REF # 1116/0719/95
MR. M. A. ZYDER.

PROPOSED TOILET POSITION AND ROOM SIZES
TO 29 WELANDS TELEFACE
STANDING.

POSITION OF PROPOSED TOILET + VENT FAN EXHAUST
(EXISTING DRAIN LINES)

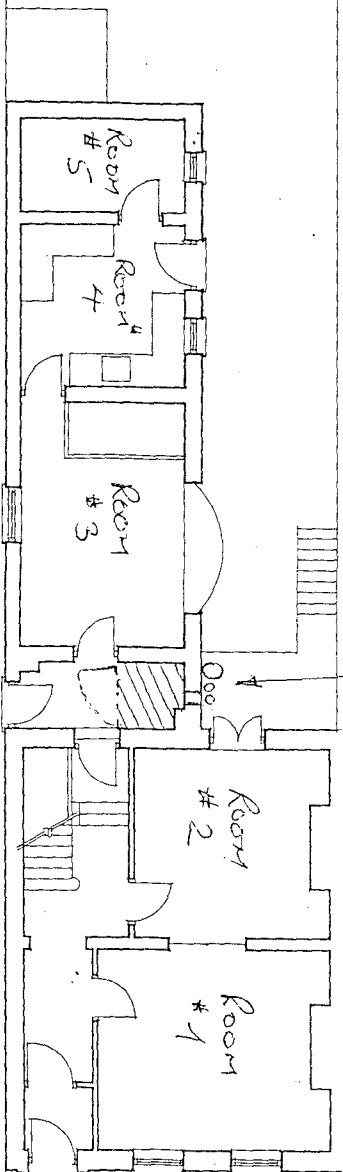
Mark Barnes looked at plan + on its basis 13. Regs
only needed for toilet. Could advise Smoke detector's
outside 1 + 2. Per 25-9
